ENGINEER'S SUPPLEMENTAL INSTRUCTIONS NO. TWELVE (12)
(Via Posting to FTP Site and Electronic Mail)

RE: Harold D. Thompson Regional Water Reclamation Facility (HDTRWRF)-Phase 1
ENGINEER'S SUPPLEMENTAL INSTRUCTIONS NO. TWELVE (ESI-012)

The ESI-012 addresses modifications to the project drawings relative to the Pumping and Disinfection Building which were issued September 16, 2011 for preparation of the CMO covering the foundation scope of work. The modifications described in this ESI appear on the Pikes Peak Regional Building Department (PPRBD) foundation only permit submittal drawings. Please distribute this ESI to any and all suppliers and subcontractors so the items described herein may be accounted for in the foundation CMO prepared for the Pumping and Disinfection Building. The following is a list of drawing modifications arranged by sheet number.

SHEET
PD-7
 OF
 -

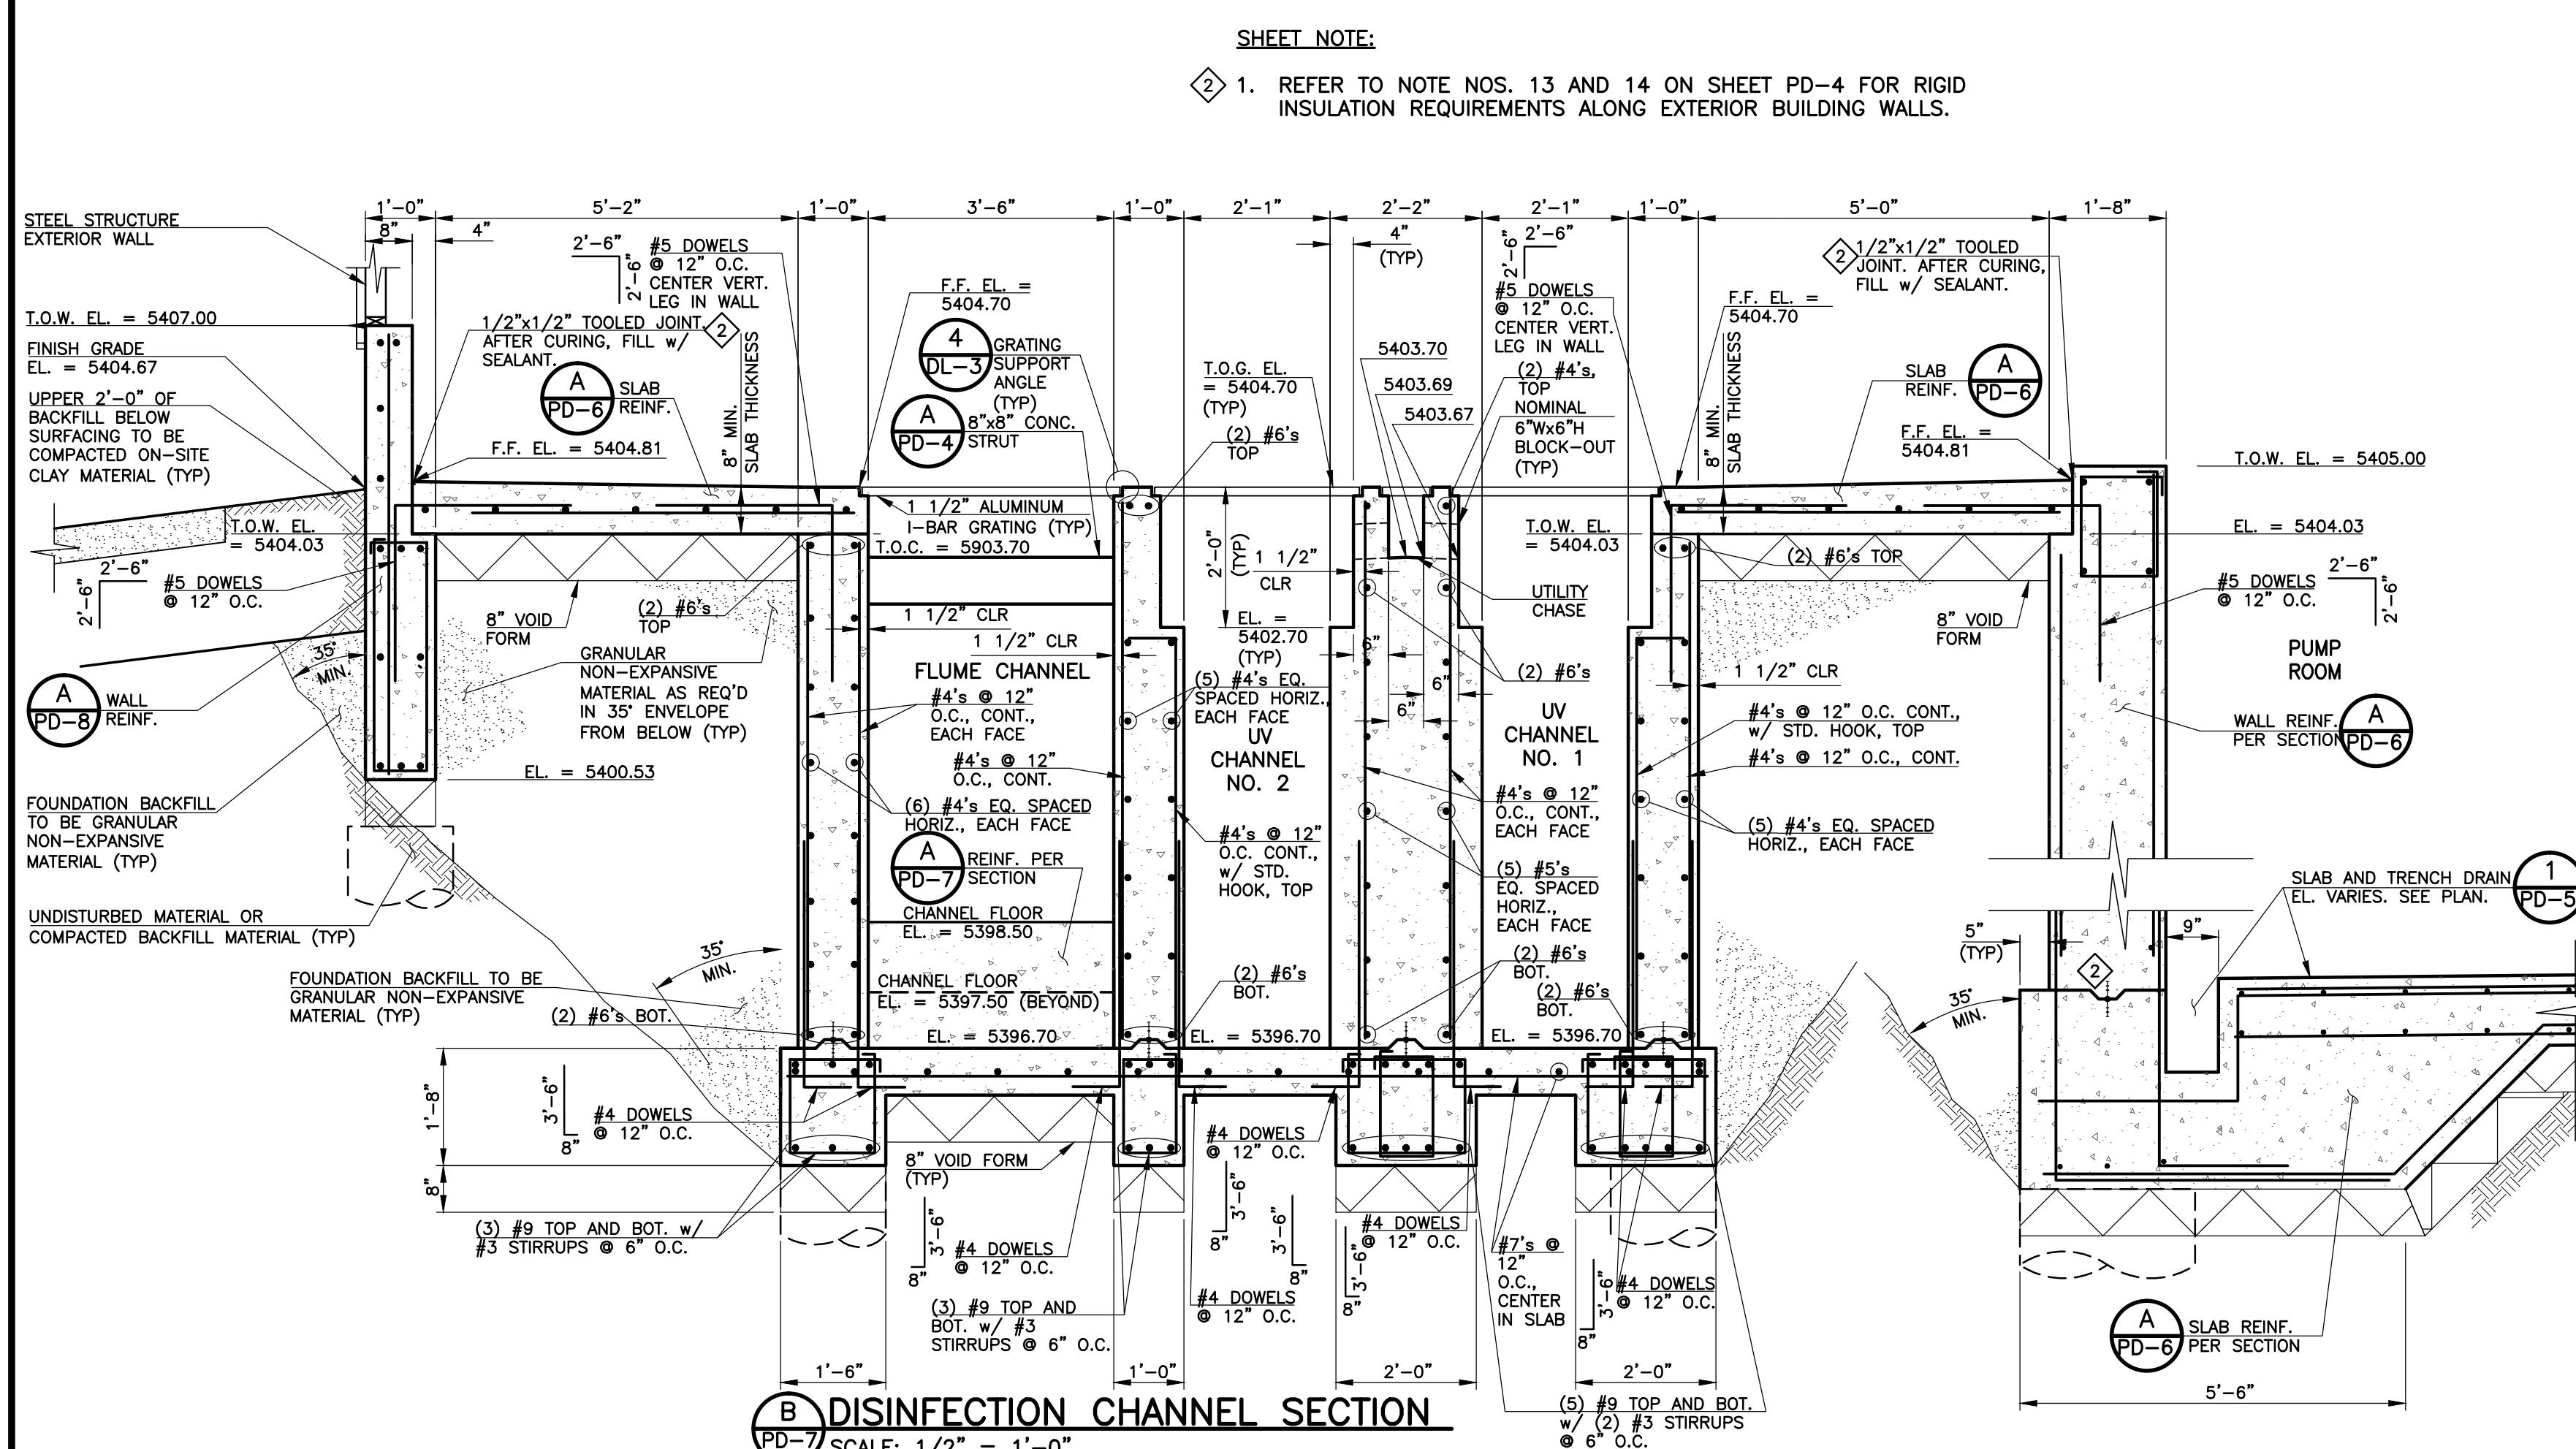
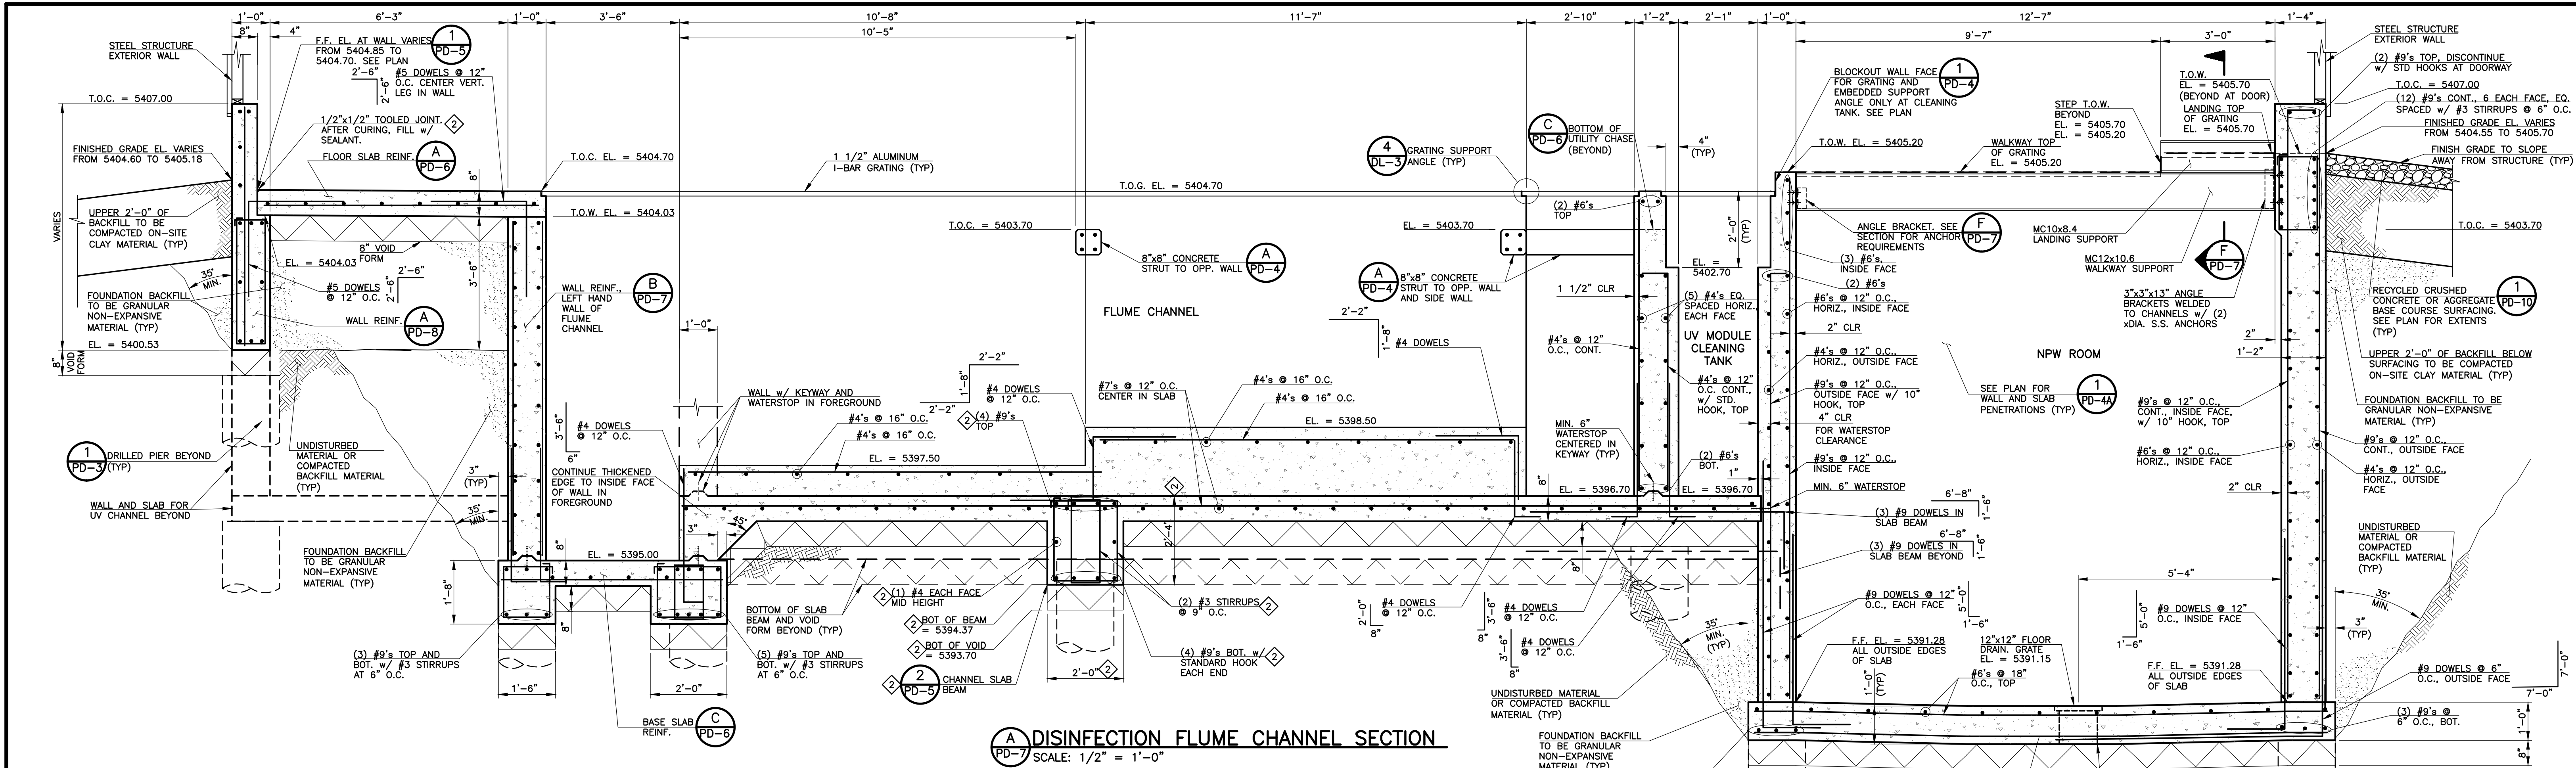
- Added Sheet Note 1 to reference Sheet PD-4 and its Note Nos. 13 and 14 regarding rigid insulation requirements
- Sheet PD-7
 - Revised Section A to indicate the requirement of a tooled joint along the perimeter of the upper level floor slab

- Revise Section A to illustrate a Channel slab beam near the midpoint of the Flume Channel, along with its associated dimensions, elevations and reinforcing requirements

- Revise Section B to indicate the requirement of a tooled joint along the perimeter of the upper level floor slab
 - Revise Section C to raise the threshold elevation of the door opening to the Hypochlorite Storage and Feed Room to 5405.28, at that door only

1 PUMPING AND DISINFECTION BUILDING DRAIN AND VENT PLAN
 SCALE: 1/4" = 1'-0"

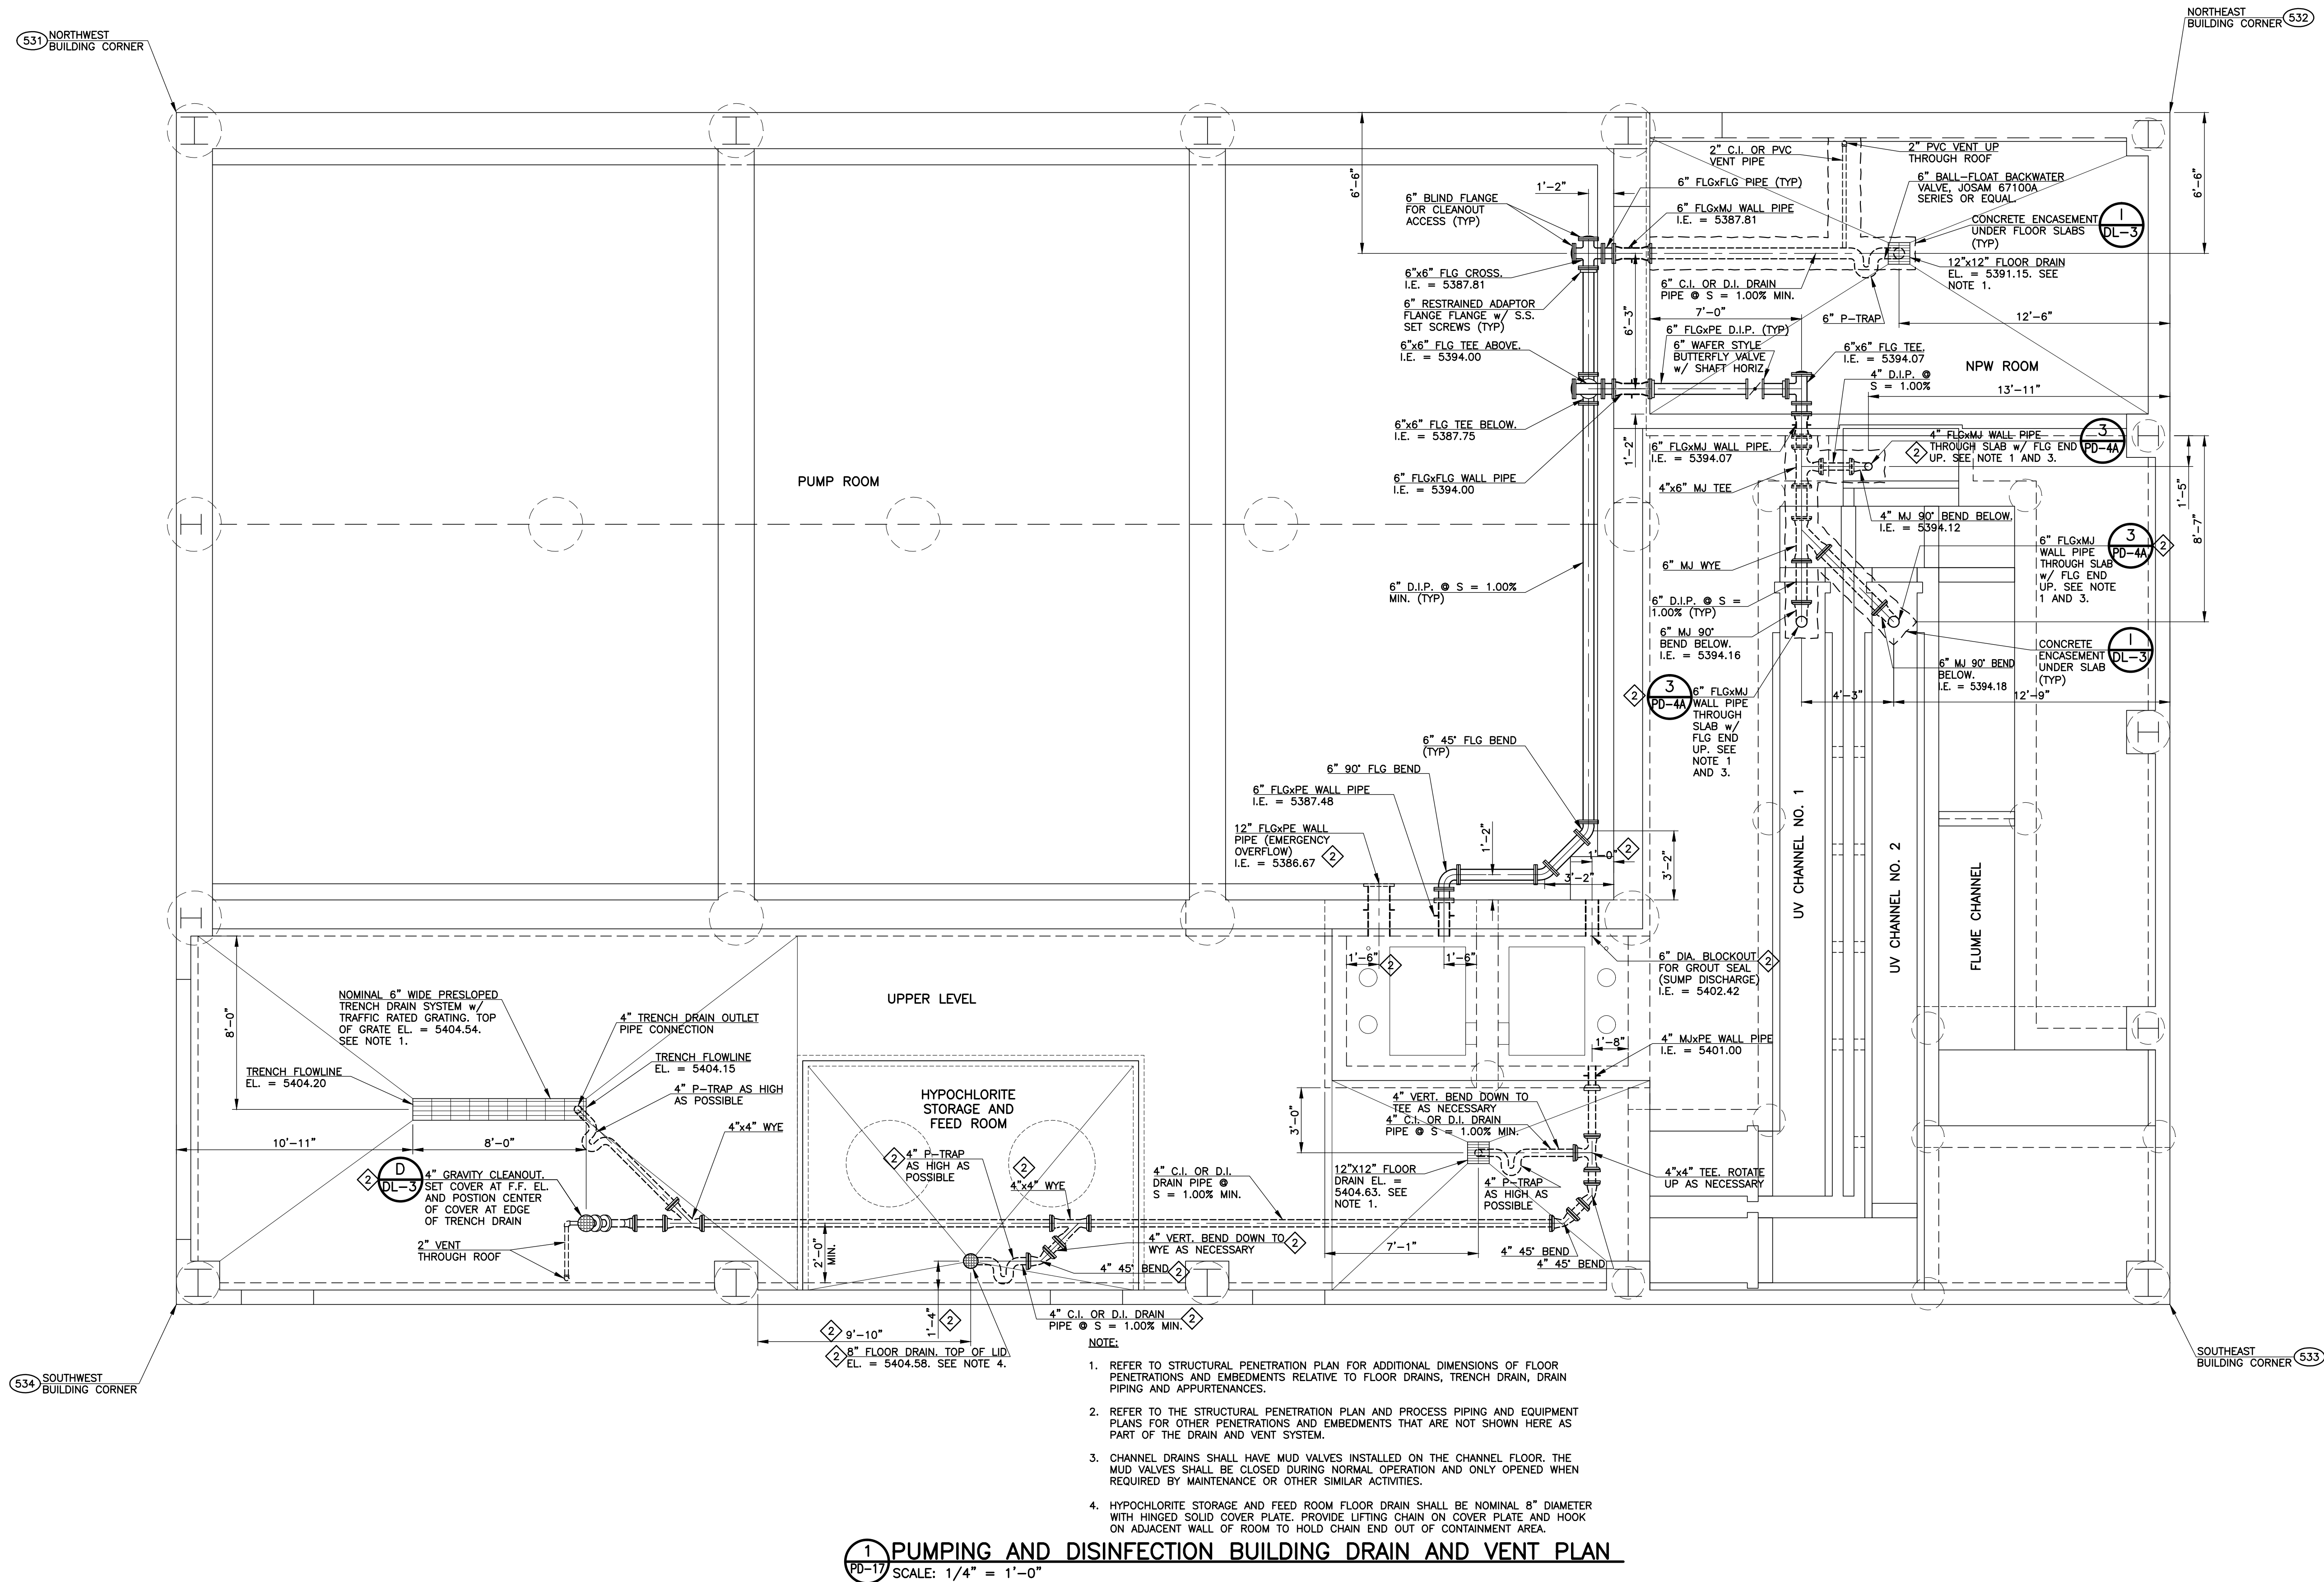
- Sheet PD-17
 - Added references to Detail 3/PD-4A, Mud Valve Recess Detail, for the three channel slab penetrations
 - Added a 6-inch diameter block out in the south Pump Room wall for the sump discharge, along with its associated dimension indicating horizontal position

- Added a 12-inch wall pipe in the south wall of the Pump Room for emergency overflow, along with its relative dimension indicating horizontal position

- Added the Hypochlorite Storage and Feed Room floor drain as previously described for Sheet PD-4, along with its associated drain piping and relative dimensions indicating its horizontal position

- Added Note 4 to describe the detailed requirements for the Hypochlorite Storage and Feed Room floor drain
 - Revised the location of the trench drain clean out to be aligned with the east end of the trench drain
